# UNITED STATES PATENT AND TRADEMARK OFFICE

APPLICATION NO.	FILING DATE	FIRST NAMED INVENTOR	ATTORNEY DOCKET NO.	CONFIRMATION NO.
10/575,860	01/25/2007	Kyu Young Kim	K-0800	6863
34610	7590	09/26/2007		
KED & ASSOCIATES, LLP P.O. Box 221200 Chantilly, VA 20153-1200			EXAMINER LEUNG, PHILIP H	
			ART UNIT 3742	PAPER NUMBER
			MAIL DATE 09/26/2007	DELIVERY MODE PAPER

<b>Office Action Summary</b>	<b>Application No.</b> 10/575,860	<b>Applicant(s)</b> KIM, KYU YOUNG	
	<b>Examiner</b> Philip H. Leung	<b>Art Unit</b> 3742

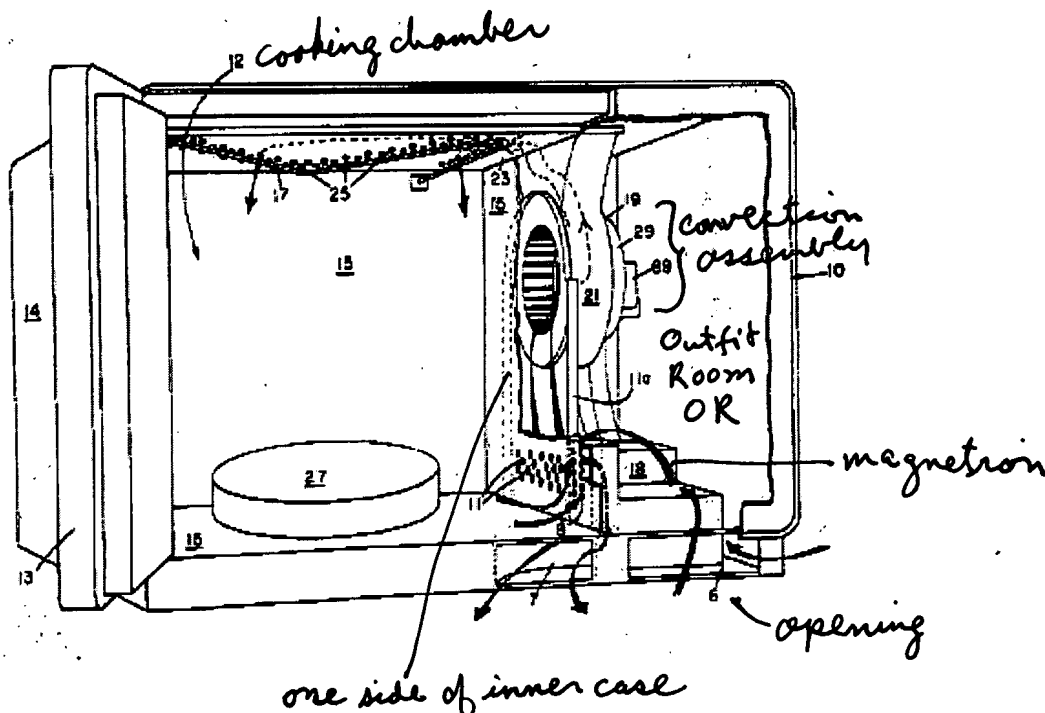
Larsen shows a microwave oven comprising: a body 10 forming an outer appearance; an inner case 15 in the body having a cooking chamber 12 formed therein; an outfit room (marked as OR) at one side of the inner case, having various electric parts, such as a magnetron 18, a high voltage transformer 92, mounted therein; and a convection assembly (19, 21, 29) mounted at a side of the inner case, for transmitting heat to the cooking chamber (see the marked-up copy of Figure 1 below).

In regard to claim 2, as shown in the drawing above, the convection assembly is in the outfit room (OR). In regard to claim 6, it also shows an opening 6 as claimed.
